# Access Compliance Report

## Public Rights-of-Way

Intersection ID: 11422	Main Street: N_MCDOWELL_ST	Cross Street: PARKWOOD_AV	Location: NE
ADA ID: 13A0DDF5B782	Ramp Type: Perp	Initial Pass/Fail: Fail	Overall Compliance: No
Severity Score: 46.25			
Codes/Mitigation Info/Possible Solution		Field Measurements/Component Compliance

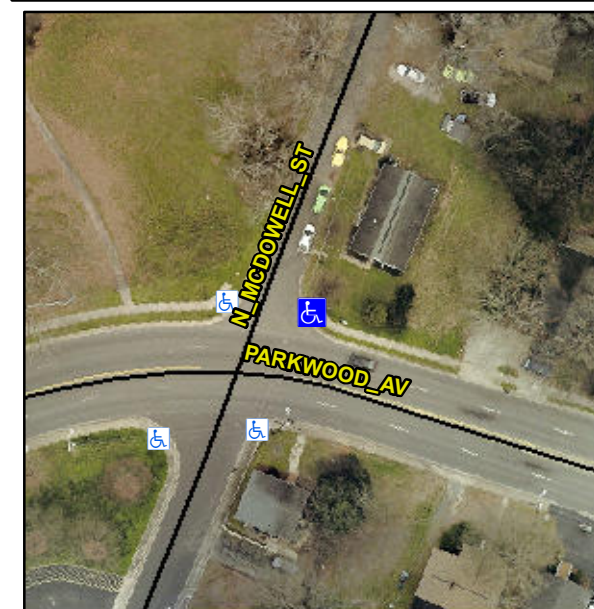
**Not Found, R304.5.1, R304.2.2, R304.5.3**

Compliance	Description	Data	Compliance	Description	Data
N/A	Ramp Length (in)	86.5	No	Ramp Slope (%)	8.8
No	Ramp Width (in)	44.5	No	Ramp XSlope (%)	11.4
N/A	Flare Type LT	N/A	N/A	Flare Type RT	N/A
N/A	Flare Slope LT (%)	N/A	N/A	Flare Slope RT (%)	N/A
N/A	Flare Traversable LT?	N/A	N/A	Flare Traversable RT?	N/A
N/A	Landing Length (in)	N/A	N/A	DWS Provided?	N/A
N/A	Landing Width (in)	N/A	N/A	DWS Contrast?	N/A
N/A	Landing Slope (%)	N/A	N/A	DWS Length (in)	N/A
N/A	Landing X Slope (%)	N/A	N/A	DWS Full Width?	N/A
N/A	Landing Curb? (Y/N)	N/A	N/A	DWS Offset (in)	N/A
N/A	Shared Landing?	N/A			
N/A	Gutter Ponding?	N/A	N/A	Gutter Slope (%)	N/A
N/A	Gutter Lip Ht (in)	N/A	N/A	Gutter X Slope (%)	N/A
N/A	Painted X Walk1?	No	N/A	Painted X Walk2?	N/A
	X Walk 1 Direction	To W		X Walk 2 Direction	N/A
N/A	X Walk 1 Width (in)	N/A	N/A	X Walk 2 Width (in)	N/A
	X Walk 1 Slope (%)	5.0		X Walk 2 Slope (%)	N/A
	X Walk 1 X Slope (%)	8.7		X Walk 2 X Slope (%)	N/A

**Remove & Replace Entire Ramp.**
